**Compliance with Planning Condition No. 2 (a) of  
Grant of Permission Ref. SDZ22A/0010.  
Permitted development in the  
Clonburris Urban Centre (CUC-S4)  
and Clonburris South East (CSE-S1 & CSE-S2)  
of the Clonburris Strategic Development Zone (SDZ).**

For convenience, we enclose the site layout plan that was submitted at Clarification of Additional Information (hereafter "CAI") stage (i.e. drawing no. 2004-PL002 – Proposed Site Plan), as well as our proposed compliance site layout plan (drawing no. 2004 – PL 006 – Proposed Site Plan).

Figure 2: CSE-S1 Site layout Plan demonstrating three storey end house E1 house type and E2 house type (highlighted purple)

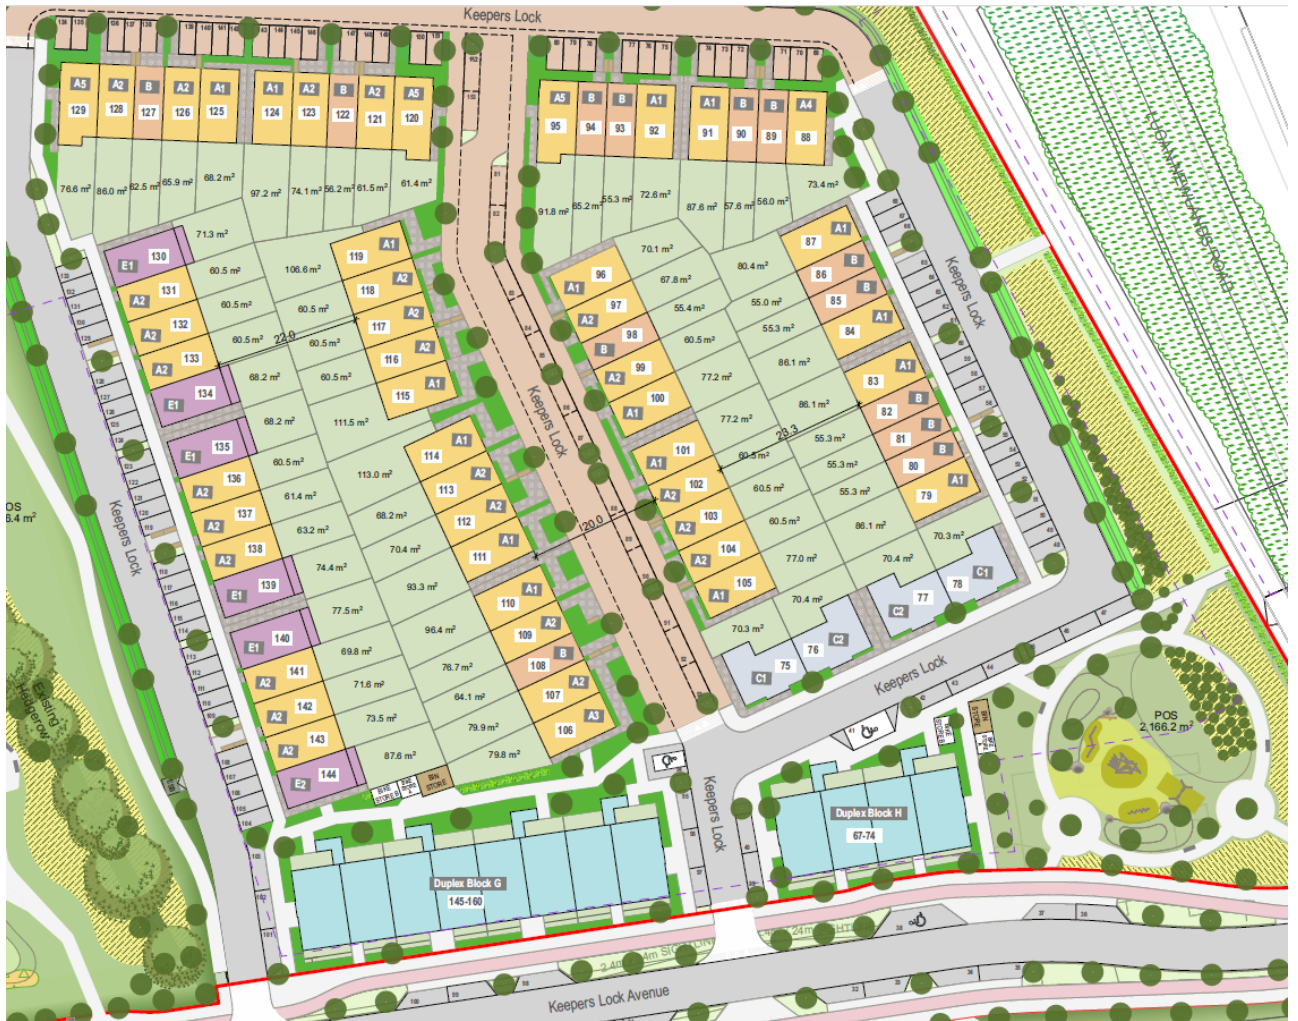
- (a) *The reconfiguration/omission of House Nos. 127 to 142 (inclusive) and replacement with house/duplex types that increase the density of this area. The residential density shall be increased so that Clonburris South East Sub Sector 1 (CSE-S1) meets the Average Net Density - Low Margin (-5dph) outlined in Table 2.13.1 of the Clonburris SDZ Planning Scheme 2019. The applicant shall confirm the total no. of units.*

In response to condition no. 2 (a) which suggests providing duplex units facing the green space to the west, in place of the previously submitted (at application stage) house nos. 127-142, it is now proposed to provide 3 storey houses along this street which are west facing, directly overlooking the central linear open space. However, if you refer to the attached site layout plan (figure 2) and site section (figure 3), you will see that this street is comprised of 3 no. terraced blocks of houses. It is proposed to bookend each block with a three storey house which is considered to add definition to the streetscape. Given the necessary density is achieved by the attached site layout plan i.e. 118 no. units in CSE-S1, we consider that there is no longer a need to provide duplex units to increase the number of units on site/at this location, however, the proposed addition of a 3 storey house type (just 6 no. units) is considered an appropriate urban design response at this location. We refer the Planning Authority to Table 2 overleaf, which demonstrates the increase in unit numbers and dwelling mix associated with CSE-S1 in compliance with condition no. 2 (a).

We submit 118 no. units to be located in CSE-S1 which equates to a net density of 51 units per hectare (considering the “white lands” as part of CSE-S1), therefore complying with condition no. 2(a) and the targets set out in Table 2.13.1.

- 70 no. houses,
- 48 no. duplex units / apartments accommodated in Duplex Blocks C, D, G, & H
- Total – 118 no. units in CSE-S1, as identified in Fig 1 and Table 2 above, on a net area of 2.1Ha.
